Service Bulletin

Number: A6-88-11

SL-P1200 & SL-P1200X
Compact Disc Players

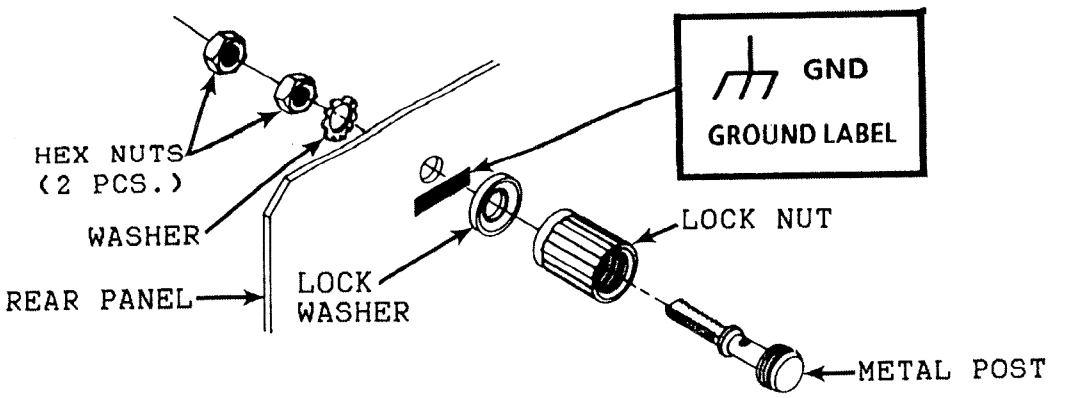
1) Mount a ground lug according to the following:
   A. Drill a 4mm hole on the indicated location of the rear panel. Make sure that no filings fall inside the unit.

B. Mount the ground lug as follows:

C. Affix the "GND" label below the ground lug.

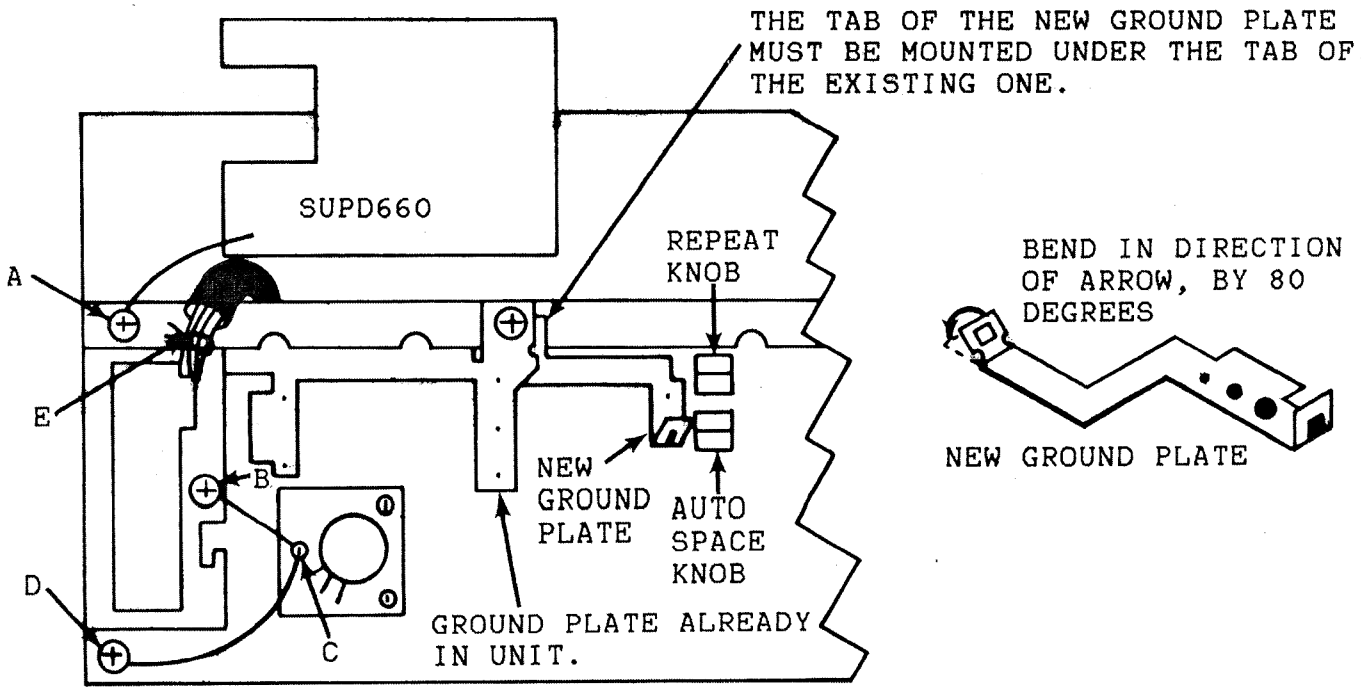
2) Modify the front panel grounding as follows, and as shown in the figure below:

A. Remove the operation PCB (KEYBOARD PCB) according to the Service Manual, page 17.
B. Cut the wire tie at point "E".
C. Remove the ground wire from points "A" and "B". Mount this wire between points "C" and "D". Use the screw (included in the kit) to mount the wire at point "D".
D. Tie the wires at point "E" by using the wire tie.
E. Remove the REPEAT and AUTO SPACE knobs.
F. Mount the new ground plate.
G. Mount the REPEAT and AUTO SPACE knobs.

SWITCH TERMINAL MODIFICATION

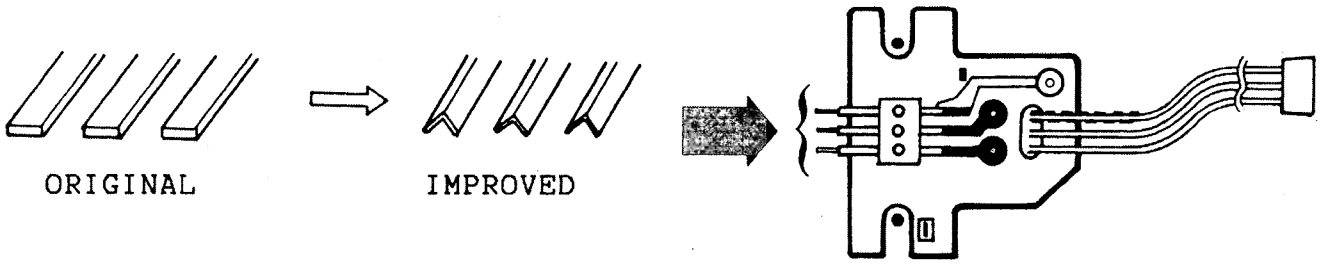
B. Check the OPEN/CLOSE detection switch S101. Make sure that all three terminals make good contact. If poor contact is noticed, replace it with the switch assembly (Part Number SWSD12001). See figure below:

SWITCH ASSEMBLY - SWSD12001

NOTE: THE SWITCH HAS BEEN IMPROVED FROM THE FEBRUARY 10, 1987 PRODUCTION ON SL-P1200, AND FROM FIRST PRODUCTION OF SL-P1200X. THE DATE CAN BE DETERMINED BY THE SERIAL NUMBER AS FOLLOWS:
